GUIDED EXPANSION POT BEARING

SHOP DRAWING REVIEW

STATE OF VERMONT
AGENCY OF TRANSPORTATION
PROJECT NO. BRF 036–1(1)
TOWNS OF ALBURG–SWANTON
VT 78 OVER MISSISQUOI BAY
BRIDGE NO. 2
ABUTMENT 1 AND 2 & PIER 7, SPAN 7 AND PIER 15, SPAN 16
POT BEARING DETAILS

COSMEC POT BEARINGS

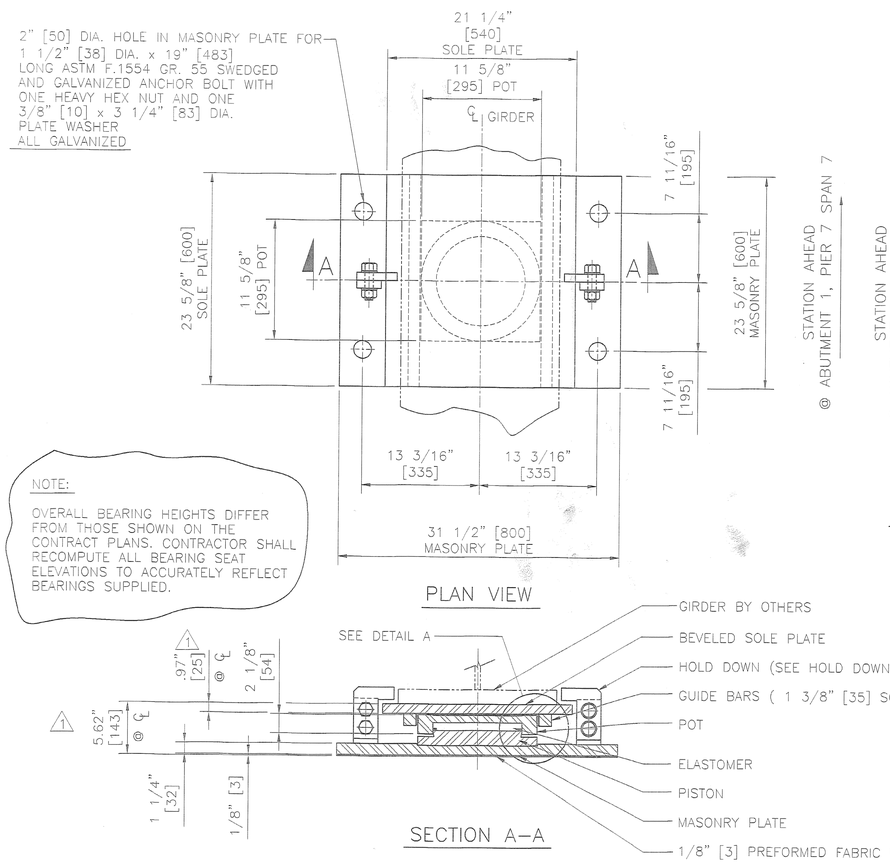
OVERALL BEARING HEIGHTS DIFFER FROM THOSE SHOWN ON THE CONTRACT PLANS. CONTRACTOR SHALL RECOMPUTE ALL BEARING SEAT ELEVATIONS TO ACCURATELY REFLECT BEARINGS SUPPLIED.

ANCHOR BOLT DETAIL

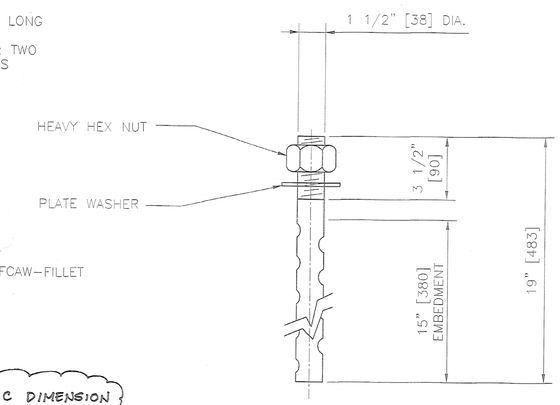
1 1/2" [38] DIA. x 19" [483] LONG ASTM F.1554 GR. 55 SWEDGED ANCHOR BOLT WITH 3 1/2" [90] THREAD ONE END, ONE HEAVY HEX NUT AND ONE 3/8" [10] x 3 1/4" [83] DIA. PLATE WASHER W/ 1 3/4"[45] DIA. HOLE
1 ALL GALVANIZED
